Product Change Notification: PCN-26-276172

TERMINAL BLOCK, PCB MOUNT, STRAIGHT SIDE WIRE ENTRY, W/ INTERLOCK 3.5mm& HEADER, STRAIGHT, UNSHROUDED 5.0MM

UL logo update and Note update to match the UL ratings .

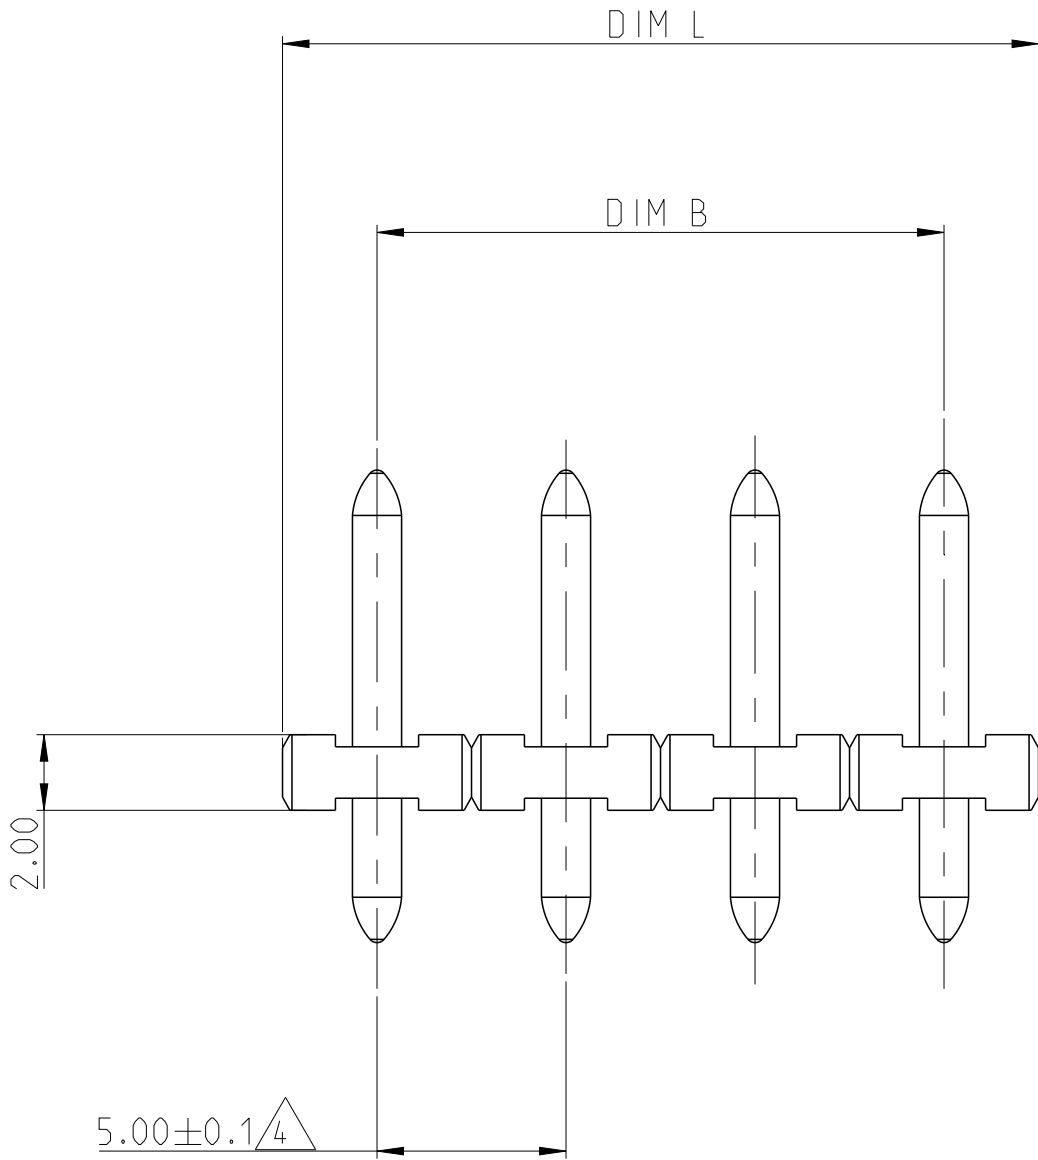
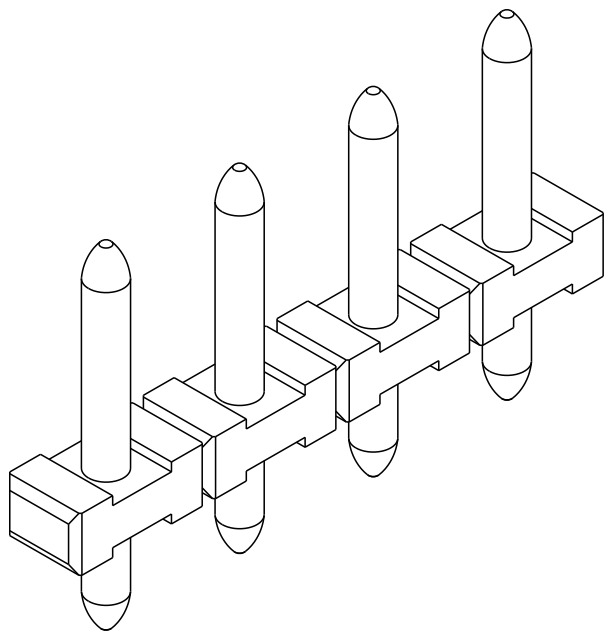
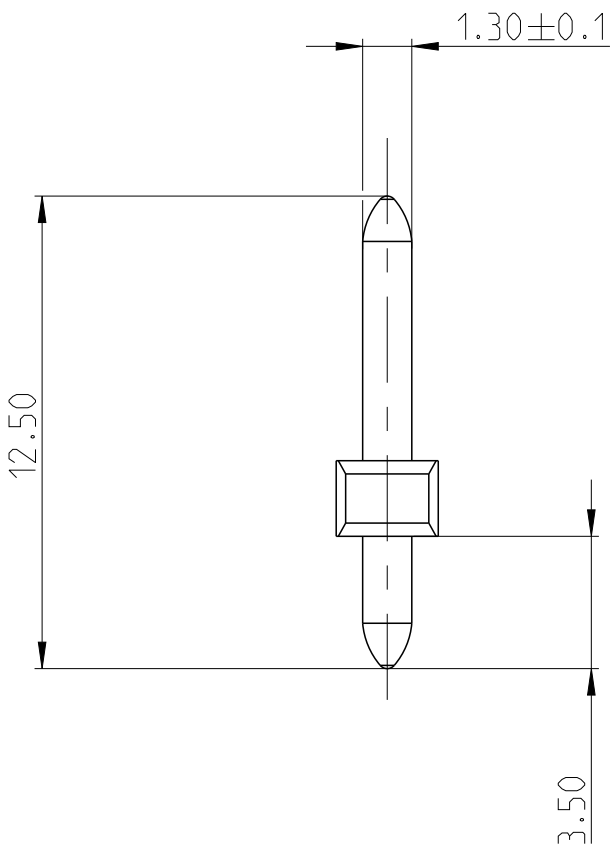
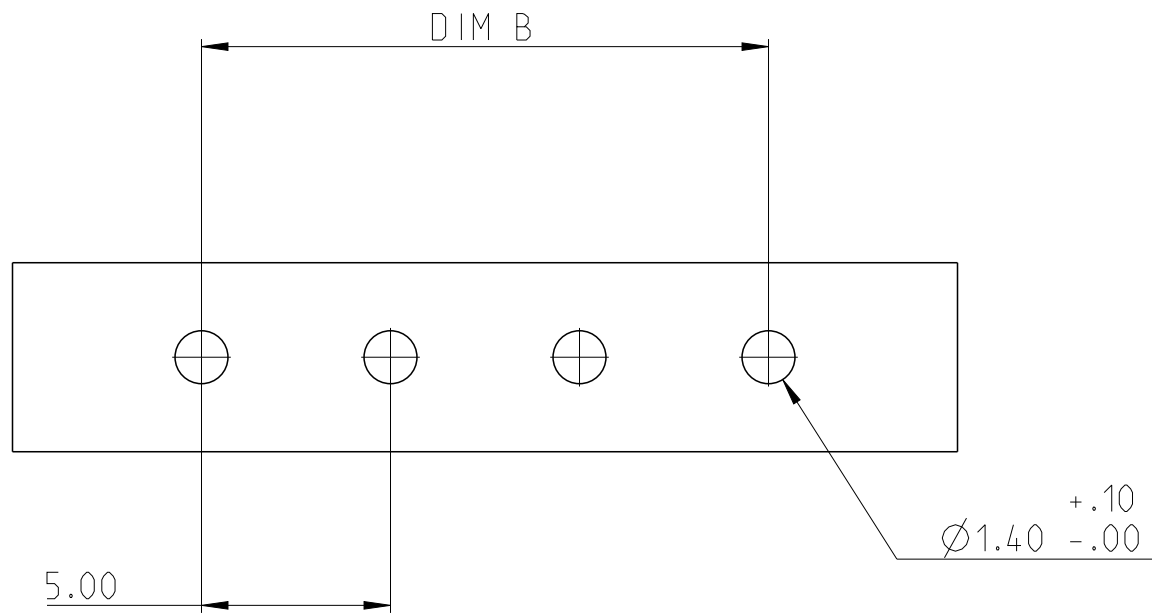
REVISIONS					
P	LTR	DESCRIPTION	DATE	DWN	APVD
	A2	NOTE UPDATE AS PER UL RATINGS	16APR2026	NMP	PS

RATED CURRENT :14 A
RATED VOLTAGE ;300V
INSULATION RESISTANCE : >1000MΩ(500V DC)
INSULATION WITHSTANDING VOLTAGE:1600VAC/MIN

6. SAFETY APPROVAL :
